Palo Verde Nuclear
Generating Station

Subject: **Palo Verde Nuclear Generating Station (PVNGS)
Units 1, 2 and 3
Docket Nos. STN 50-528/529/530
Response to NRC Request for Additional Information
Regarding Request for Operating License Amendment –
Modification to Diesel Generator Jacket Water
Makeup System (TAC Nos. MC7288, MC7289 AND MC7290)**

**APS' Response to NRC Request for Additional
Information Regarding Request for Operating License
Amendment – Modification to Diesel Generator Jacket
Water Makeup System**

Figure 1 below provides a typical description of the Diesel Generator Jacket Water Standpipe for both diesel generators in all three units.

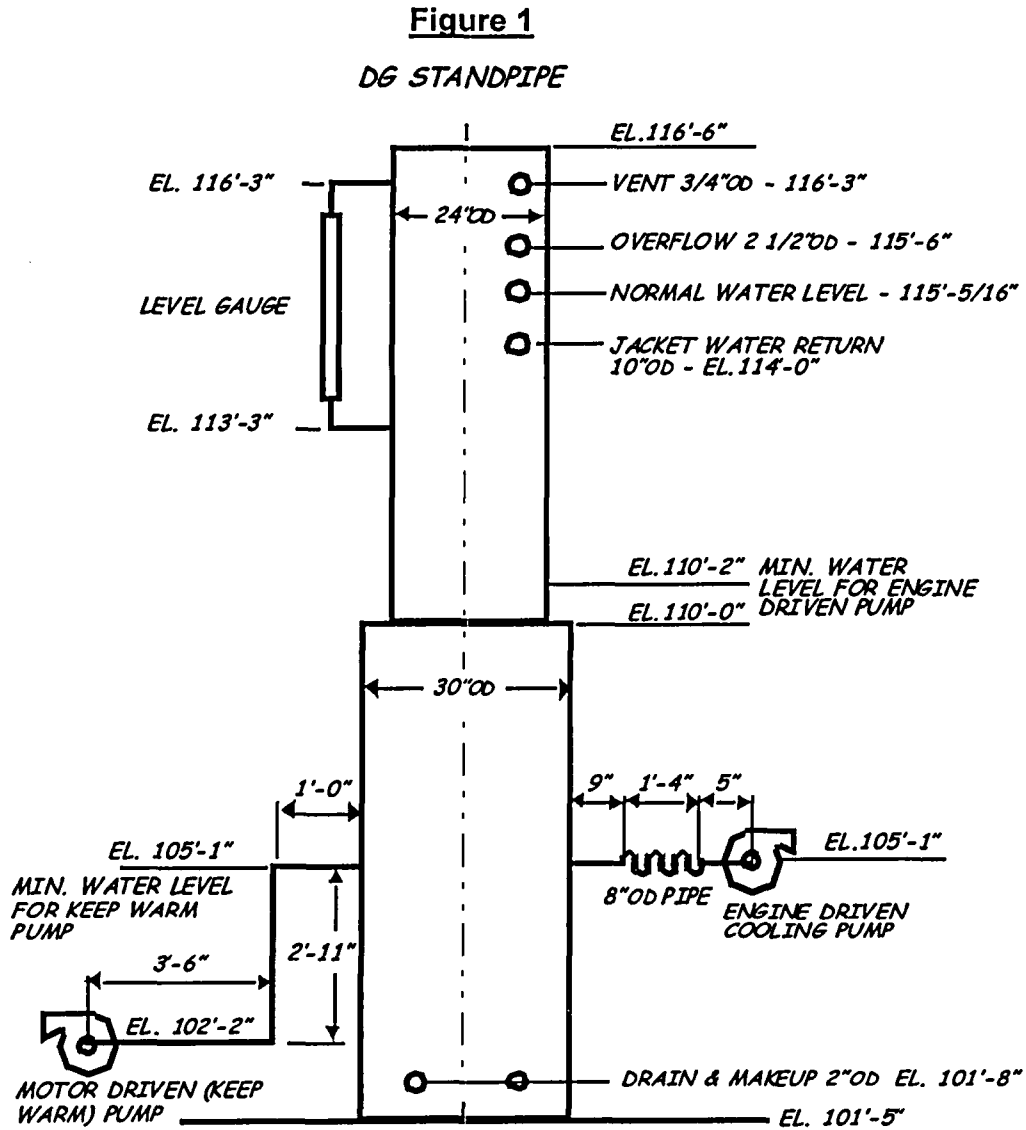
In the LAR submittal, APS states that the DGCWS is designed as a closed loop system with only a minor loss of inventory postulated during any of its operating modes, and it has an administrative allowable leakage limit of 1.6 gph. Define what the "minor loss" is, and justify how the "minor loss" and the administrative allowable leakage limit of 1.6 gph are established.

Normal or "minor loss" is defined as loss of jacket water (JW) from valve packing and/or pump mechanical seals and is predicted to be 0.124 gal/hr (gph). Leakage from valve stems is considered to be equal to the maximum allowable seat leakage (2 cm³/hr per inch of nominal valve size). Leakage from mechanical pump seals is conservatively determined to be 60 drops/min or 6 ounces per hour. Normal system evaporation of JW is considered to be negligible (less than 0.0006 gph).

The administrative allowed JW leakage rate of 1.6 gph is based on the loss of 10" of water in the JW standpipe site glass in a 12 hour period. The 10" sight glass level was chosen as it is verifiable by Operator rounds. This administrative limit constitutes a volume of 19.58 gals between the lower site glass tap-elevation of 113'-3" and a sight glass level of 10" (elevation 114'-1"). A leakage rate of 1.6 gph allows verifiable monitoring of the loss of this volume (19.58 gal) given 12-hour operator rounds. 19.58 gal/12 hours = 1.6 gph.

It should be noted that the standpipe level required to maintain minimum NPSH is 110'-2" (approximately 3 feet below the bottom tap of the sight glass). This constitutes a volume difference of 72.4 gallons between the bottom tap of the sight glass and the minimum NPSH level. This results in a maximum allowable leakage over a 25 hour period (for Appendix R considerations) of 2.9 gph (72.4gal/25 hours = 2.9 gph).

Verifying that leakage is within the administrative limit of 1.6 gph, provides a measure of confidence that the diesel generator will have an adequate volume under conditions in which no operator action is credited for 25 hrs.
